HISTORIC AND DESIGN REVIEW COMMISSION

HDRC CASE NO: 2016-517

ADDRESS: 2231 SE MILITARY DR

TYPE OF WORK: Installation of a multi-tenant pylon sign

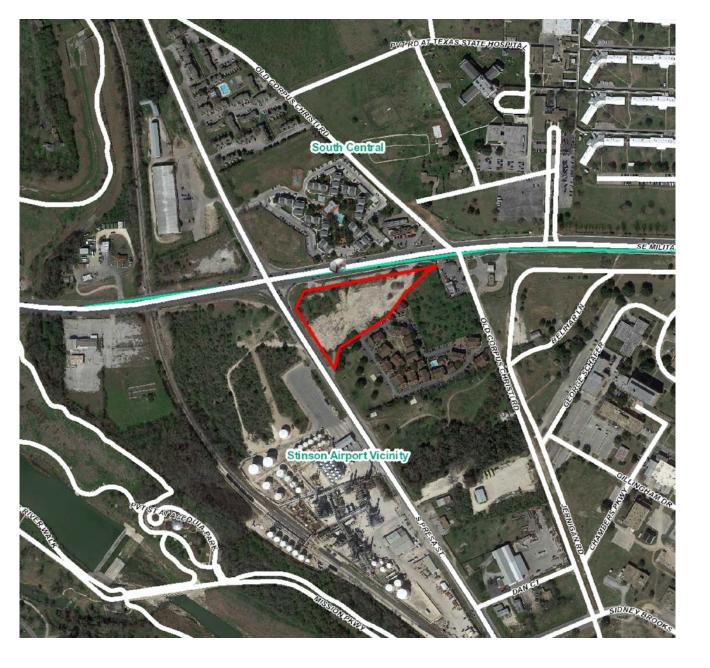
- a. The applicant has proposed to install a multi-tenant pylon sign at the new construction located at 2231 SE Military Drive. The applicant has proposed for the pylon sign to be thirty-five (35) feet in height, feature an overall width of twenty (20) feet and feature six internally illuminated cabinets with an aluminum base. The applicant's proposal is consistent with the UDC Section 35-678(c) in regards to lighting.

- b. In regards to size, the UDC allows signage of up to fifty (50) square feet for each business or service. The proposed signage exceeds fifty (50) square feet; however, staff finds that given the commercial nature of SE Military drive which features a total of six lanes of traffic flowing east and west and the development for which this signage is proposed, the requested height and width are appropriate. Additionally, the proposed signage is consistent with signage found at other locations along SE Military that serve businesses with a similar number of tenants. The re facing of signage in regards to this pylon sign may be approved administratively.

c. This request was original heard by the HDRC on December 21, 2016, where it was referred to the Design Review Committee. The DRC reviewed this request on January 10, 2017, where the committee noted that the proposed sign at a height of thirty-five (35) feet was appropriate for the setting and that the overall signage proposal was appropriate.

Staff recommends approval as submitted based on findings a and b.
